BRAKES - ISABELLA
NOTICE OF MODIFICATION

OMOBIL- UND MOTOREN-WERKE

Bremen, 23 June 1961

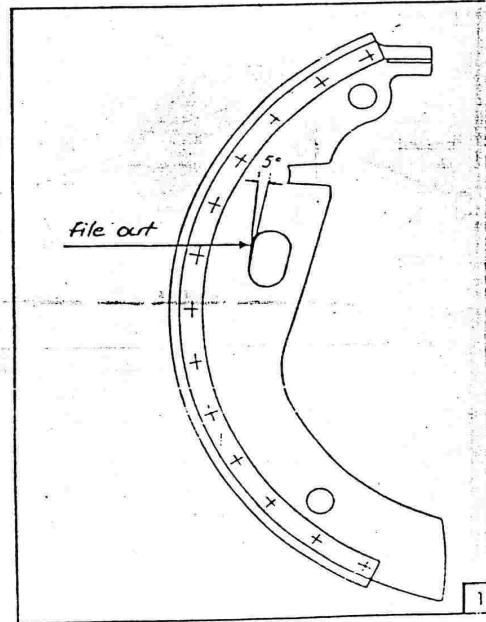
the angle of the aperture in the brake shoe (for the adjuster) has been changed from 10° to 15° in order to obtain a more even working of the brakes.

On vehicles, which despite faultless adjustment and bleeding still show variations in braking power (e.g. pulling to one side, excessive pedal travel, no hard pressure point) a modification to the adjuster aperture as shown in Fig.1 is advised.

Most vital for carrying out the installation of the brakes without trouble is to ensure that the adjustment eccentrics are in the correct position in the apertures in the brake shoes. This must be checked before fitting the brake drums. The eccentrics should be positioned as in Fig. 2.
